Service Bulletin 2017-002

Subject: Ring position on SIFE main risers

Status: mandatory before the next jump

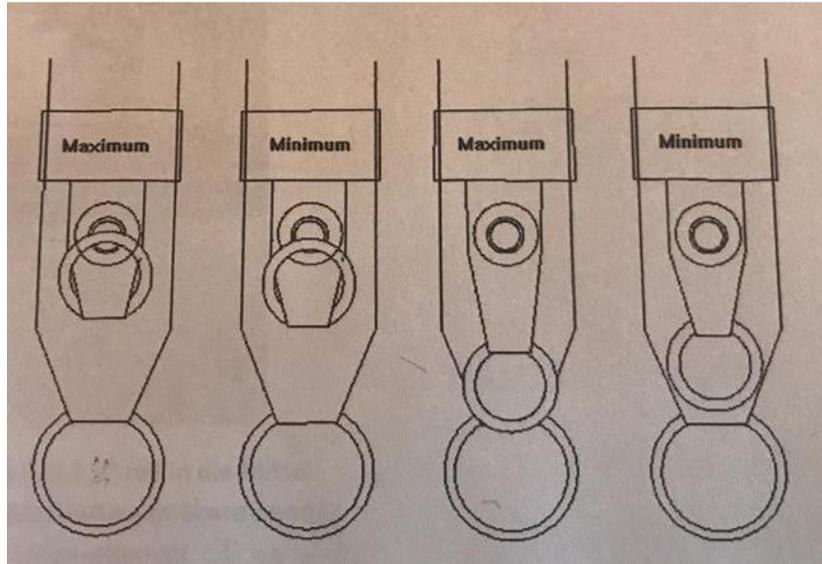
We have been informed that during the simulation of a cutaway procedure, the 3-ring-system released only after a short tug on the risers. The result of our investigations is that the position of the small ring on the affected main risers may not meet the design specifications.

1. Check the ring position on your main risers with the following figure:

2. If your main risers do not meet the design specifications, or if you are unsure please send us an e-mail to office@sife.at.

The main riser replacement will be free of charge.
